# S021 Battery Monitor Shortage

3/2/2023

Battery Monitor Shortage

Figure 64: Battery State of Charge Monitor

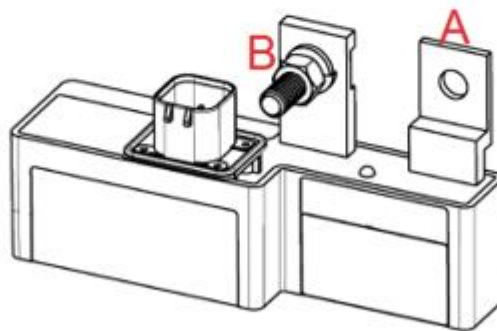
In order for the battery *SoC* monitor to report accurate charge and battery draw, it must be connected in a specific manner. Terminal **A** of the *SoC* monitor is to be mounted directly onto a negative battery terminal. All other negative cables, with the exception of the starter and interconnect cables, are to be mounted onto terminal **B**. Failure to follow this installation specification will reduce Auto Start system performance and may generate *DTCs*. The connector on the battery *SoC* module accepts the harness connector for *CAN* communication with the chassis node.

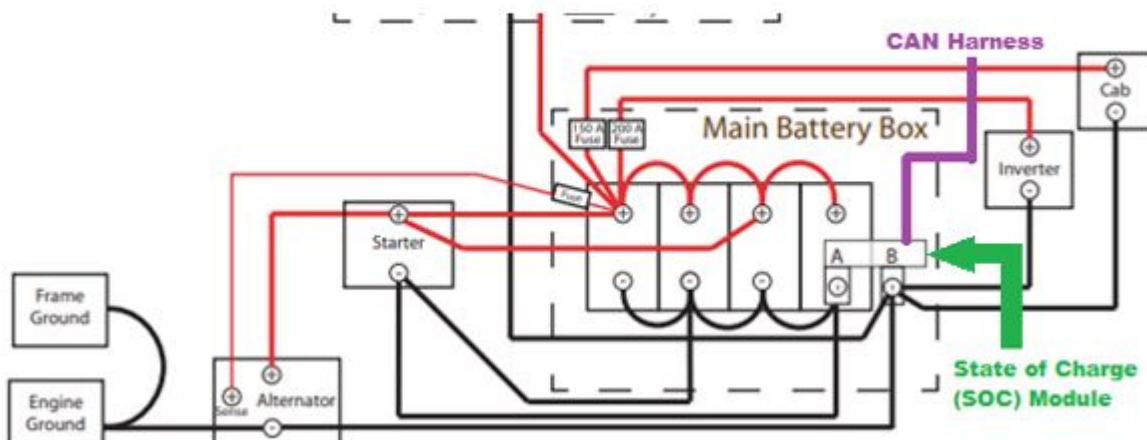
Main and auxiliary battery monitors follow a very similar installation process and look very similar, however they are different. Verify part numbers and ensure proper monitor is installed in proper location.
